APPLICANT: Fairfield Residential, LLC

PETITION NO: Z-82

PROPOSED ZONING: RM-12

PROPOSED USE: Apartments

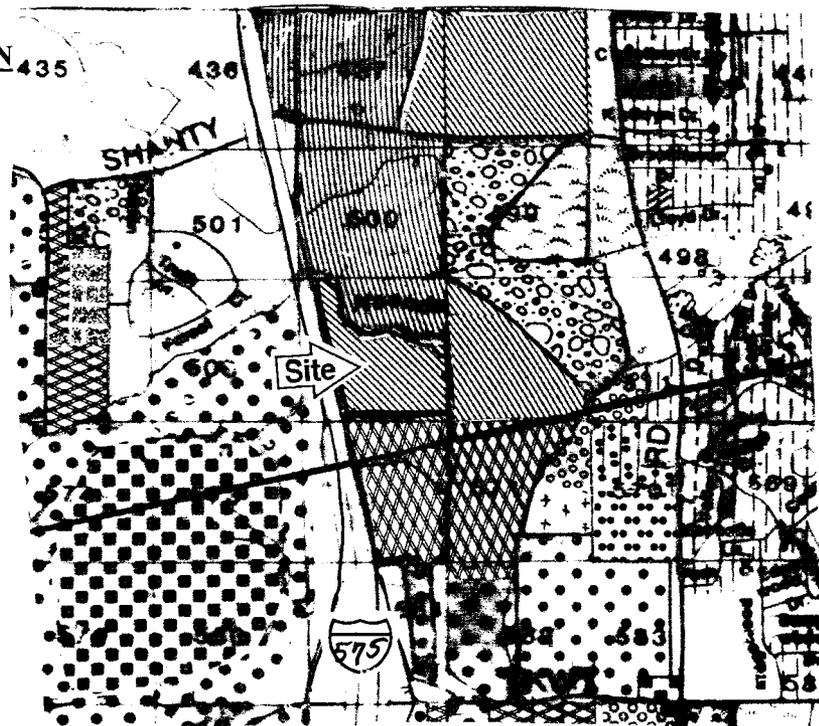
Location: identified on site plan

- No Stormwater controls shown _____
- Copy of survey is not current - Additional comments may be forthcoming when current site conditions are exposed.
- No site improvements showing on exhibit.
